**Florida Department of
Environmental Protection
Inspection Checklist**

Facility Name: HARDEE COUNTY REGIONAL LANDFILL
On-site Inspection Start Date: 11/18/2020
On-site Inspection End Date: 11/18/2020
WACS No.: 40612
Facility Street Address: 685 AIRPORT ROAD
City: WAUCHULA
County Name: HARDEE
Zip: 33873

Routine Operation Inspection for Landfill - Class I

B) Fill Sequence 4**B) Fill Sequence 4****C) Distance Between Edge & Lifts**

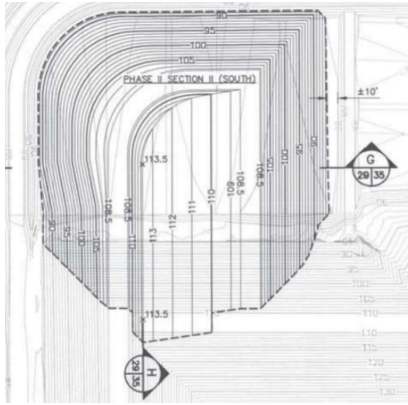
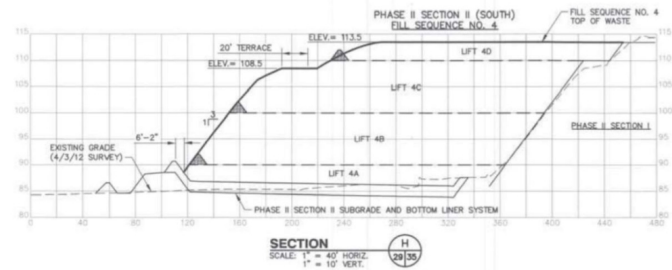
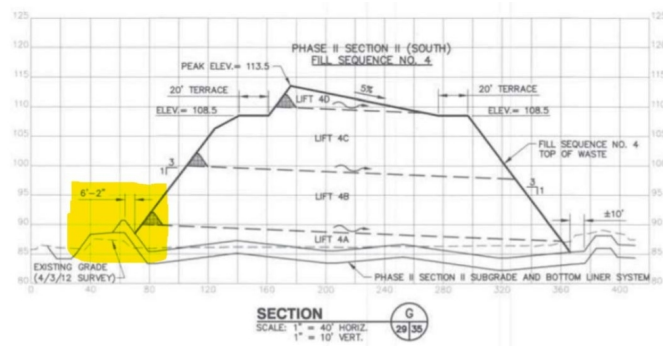
B) Per section K.2.f.2 of the facility's Operation Plan, Fill Sequence 4 involves the filling of the south portion of Phase II Section II. During the inspection, it appeared that the top lifts of Fill Sequence 4, elevations between 108.5 and 113.5, were not filled in entirely to connect this portion of Phase II Section II to the side slope of Phase II Section I. On the Fill Sequence 4 drawings, these elevations are contained within lifts 4C and 4D and are represented by the attachments entitled "Fill Sequence 4".

C) At the time of the inspection, it was unclear if the south and center portions of Phase II Section II were offset from the edge of the disposal at the correct distance. Per the Fill Sequence 4 drawings, it appears that each lift within these portions of Phase II Section II must be offset six feet and two inches from the edge of disposal, as depicted in the attachment entitled "Distance Between Edge & Lifts".

B) Please provide photo documentation demonstrating that the waste lifts contained between the elevations of 108.5 and 113.5 were filled in accordance with the Fill Sequence 4 drawings. In addition, following the filling of these lifts, please provide a survey of the landfill to demonstrate that Fill Sequence 4 has been completed in accordance with the operation plan and drawings. Please provide this documentation to the Department within 30 calendar days of the date listed on the attached Warning Letter. Please also see Item 2.19 for additional information regarding this matter.

C) Please provide documentation demonstrating that the distance between the waste and the edge of disposal meets the distance requirement outlined in Fill Sequence 4 for the south and center portions of Phase II Section II. This documentation can be presented within the landfill survey requested in Item A above. Please provide this documentation to the Department within 30 calendar days of the date listed on the attached Warning Letter.

A) Area Needs Intermediate Cover

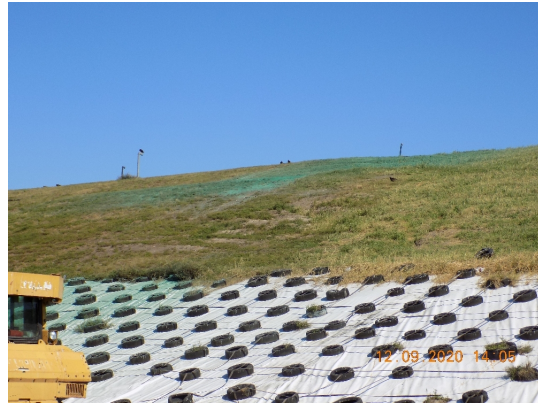
Explanation: A) Please see Item 2.13, Item B for information regarding this Violation. Per Item 2.13, Item B, the top lifts of the south portion of Phase II Section II must be filled in with waste. Intermediate cover must be applied in this area in accordance with Condition C.8.b. of the facility's Permit (No. 38414-016-SO/01) and Section K.7.g of the Operation Plan.

B) The cover on the side slopes of Phase I could not be inspected thoroughly due to the slopes not being mowed. Photo documentation demonstrating that portions of the eastern and western side slopes of this Phase were mowed was provided via email by the facility on November 23, 2020. However, photo documentation of

A) Documentation demonstrating that intermediate cover was applied to the top lifts of the south portion of Phase II Section II.

A) Leachate Discharge

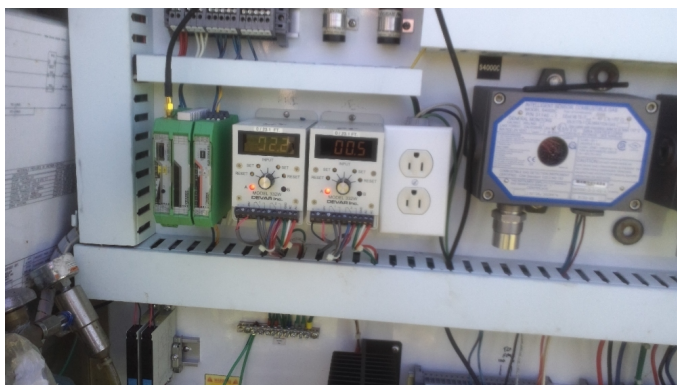
- Explanation:
- A) During the inspection, a flex hose connected to the Leachate Collection System (LCS) and Leachate Detection System (LDS) riser pipes discharging leachate. The pump was turned off immediately by facility personnel. Photo documentation demonstrating that the connector for the flex hose that was discharging during the inspection was replaced was provided via email on December 7, 2020. This is the second leachate discharge observed by Department at this facility within the last 1.5 years.

- Corrective Action:
- A) Due to the repeated nature of these discharges, it may be warranted that some type of measure be taken to ensure leachate is not discharging outside of the landfill areas in the future. Please continue to ensure that the flex hoses and their connections to the LCS and LDS riser pipes are in good condition and do not leak when in operation.
